ADDENDUM NO. 2

McNear Park Sewer Main Replacement Project and McNear Park Water Main Replacement Project City Project Numbers C66402143 and C67502020

January 25, 2021

DETAIL 1

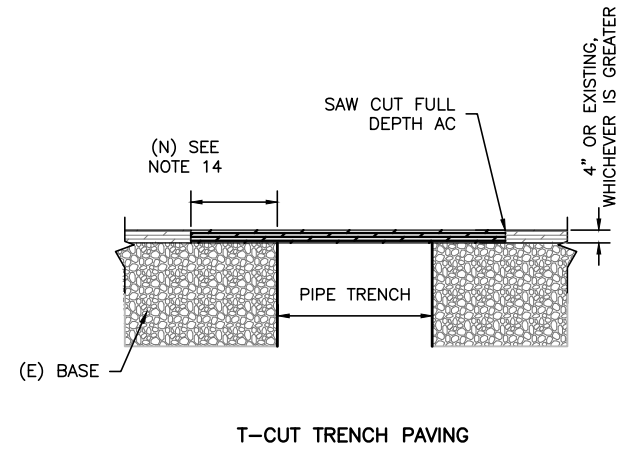
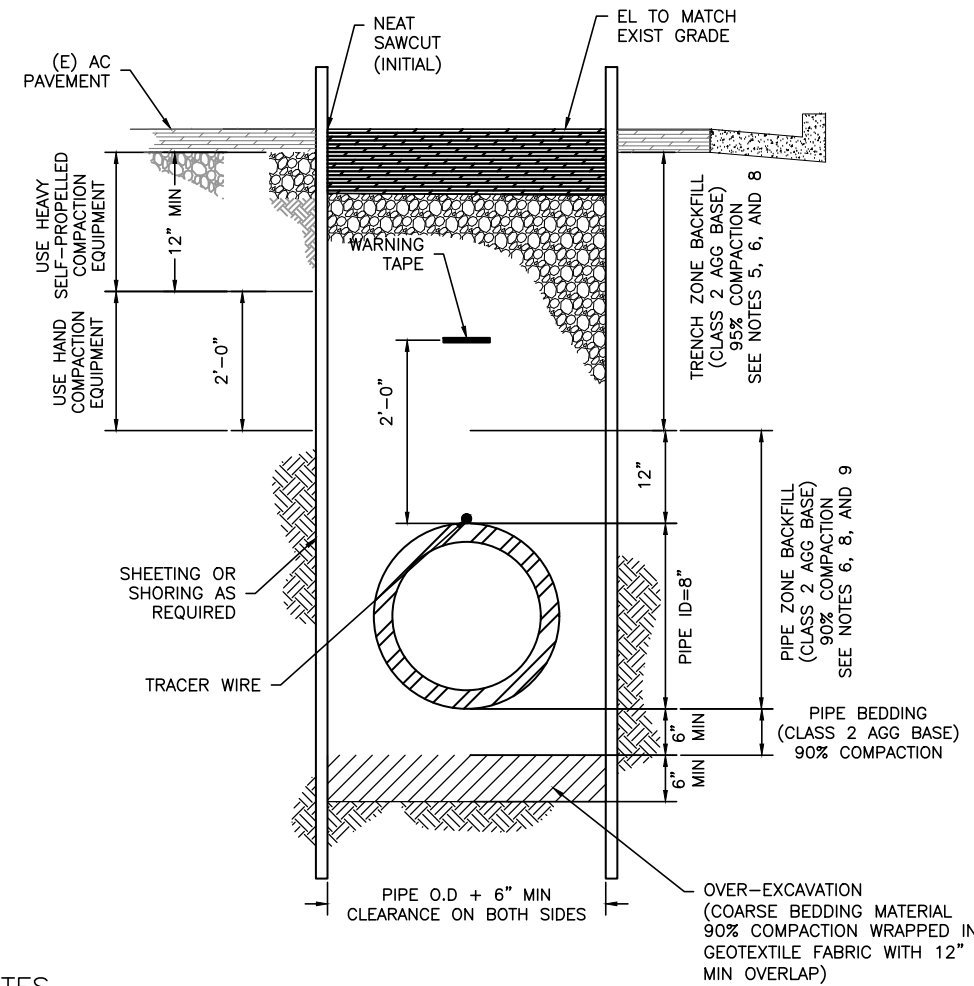
1. **Delete** Contract Drawing Sheet D1 in its entirety. **Replace** with Contract Drawing D1 included in this Addendum No. 2.

Question #1: The details within the drawings show no “T-cut” for the trench repaving but City Standard Detail 219 for trench paving shows a “T cut”. Please clarify?

Response #1: *A new detail sheet for trench paving has been issued and is part of this addendum. The original ‘Detail 1’ shown in the drawing was meant to show pipe trench information in areas where pavement rehabilitation was to take place. Trench repaving in areas where no pavement rehabilitation is being done shall adhere to City Standard Detail 219. The new ‘Detail 1’ shown on Sheet D1 reflects this.*
